RADIAN
CORPORATION
May 30, 1989

Re: Revised Work Plan
Stage 2 Remedial Investigation
Emerson Power Transmission, Ithaca, New York

REVISED WORK PLAN FOR
STAGE 2 REMEDIAL INVESTIGATION
EMERSON POWER TRANSMISSION
ITHACA, NEW YORK

Figure 2. Locations of Existing and Proposed Monitoring Wells at Emerson Power Transmission Ithaca, New York

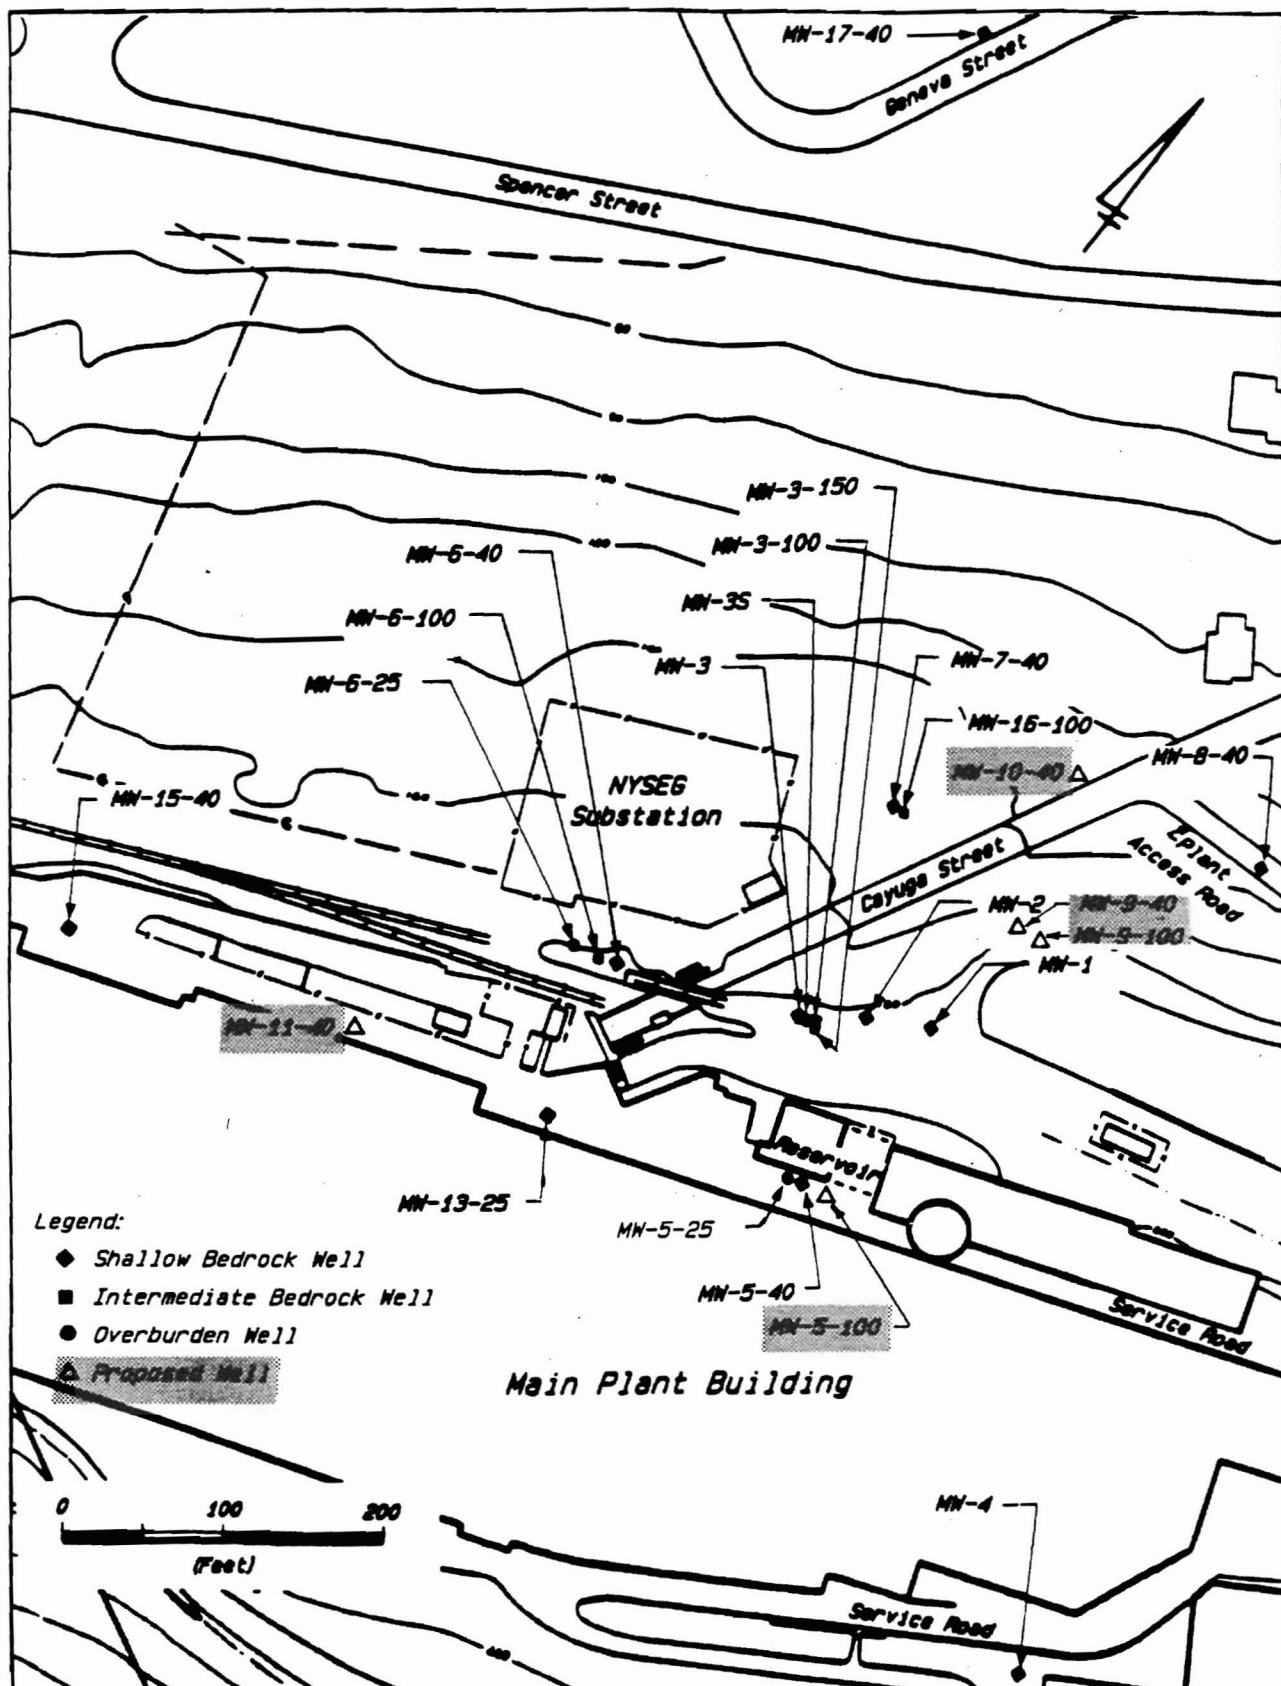
2. In a conversation with Ms. McCormick, it was agreed upon that five Stage 2 wells will be installed, but that some of the locations would change. Well MW-10-40 will be moved from the proposed location to Spencer Street, in a east-northeasterly direction from wells MW-1, MW-2, and MW-3 and along the orientation of the fracture traces.
3. The MW-9 well cluster will be moved from the proposed location to a position at the intersection of the plant access road and Cayuga Street. The wells will be located on the southeastern corner of this intersection, which will place them in the northeasterly downgradient direction from the MW-3 cluster.
4. Seep F was added to the seep sampling program. Its omission was an oversight.

Proposed well MW-10-40 will be located along Spencer Street, east-northeast of the MW-3 and MW-2 wells and along the orientation of the fractures in the bedrock. To provide additional information on the furthest lateral extent of TCE and associated compounds in this area, well MW-10-40 will be located downgradient of the reservoir and the property line, and installed to a depth of approximately 40 feet.
